## **Technical Service Information**

## THM 440-T4 SPACER PLATE I.D. (3-2 LINE CONTROL)

Figure 1

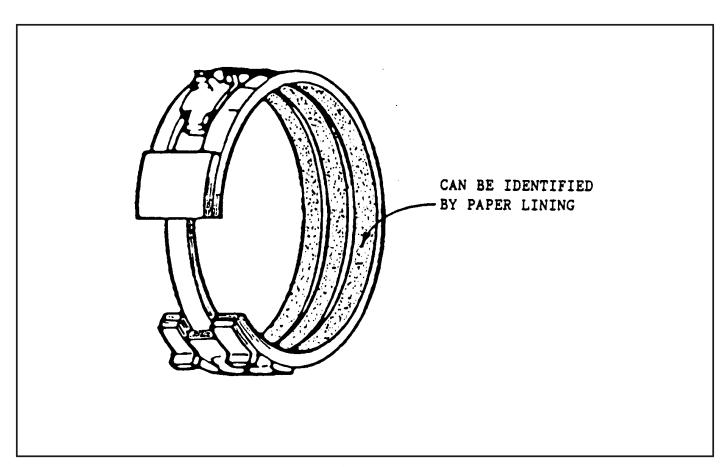
CHANGE: A 4th design Reverse Band Assembly is now in production on all THM 440-T4

transaxles.

**REASON:** To help eliminate a harsh reverse apply condition.

PARTS AFFECTED: (1) REVERSE BAND ASSEMBLY -been changed, The lining on the reverse band has

once again and can be identified by the "Paper" lining on the band itself (See Figure 1).

It will retro-fit back to all previous models and is highly recommended to help eliminate

a harsh reverse apply condition.
